Bank Street Park
Blackwattle Bay / Tjerruing

SSD-53386706

Site Audit Report (Ramboll Australia Pty Ltd)

SITE AUDIT REPORT REMEDIATION ACTION PLAN, BANK STREET PARK, PYRMONT NSW

FIGURE 8

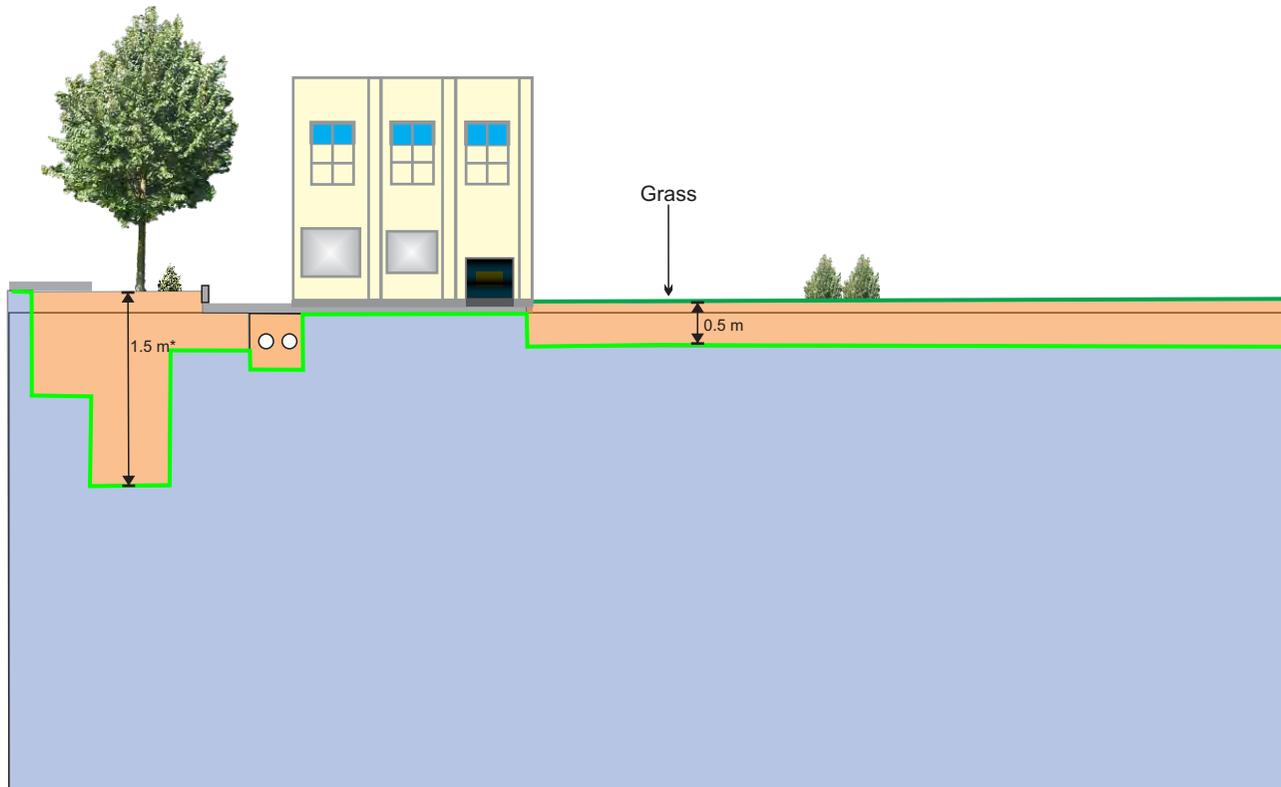
2. Figure 8 (Page 100; and Section 7.2.4 Page 61) indicates that remediation is required across the 'Site' except for Lot 6 DP803160. However, the RAP does not clarify why remediation is not needed at Lot 6. Please amend as required.
[This has been updated and provided in the revised report.](#)

6. Section 4.1 (Page 36): 2nd paragraph appears to indicate that specific Areas of Environmental Concern (AECs) are shown on Figure 8 (Page 100). However, Figure 8 does not show the AECs.
[Figure 8 shows the potential UST and vents observed onsite, in addition to the fill identified across the site to be contaminated with heavy metals, TRH, PAHs and asbestos. The Figure has been updated to show the contained contaminated material from previous remediation works at 5-11 Bank Street for clarity.](#)
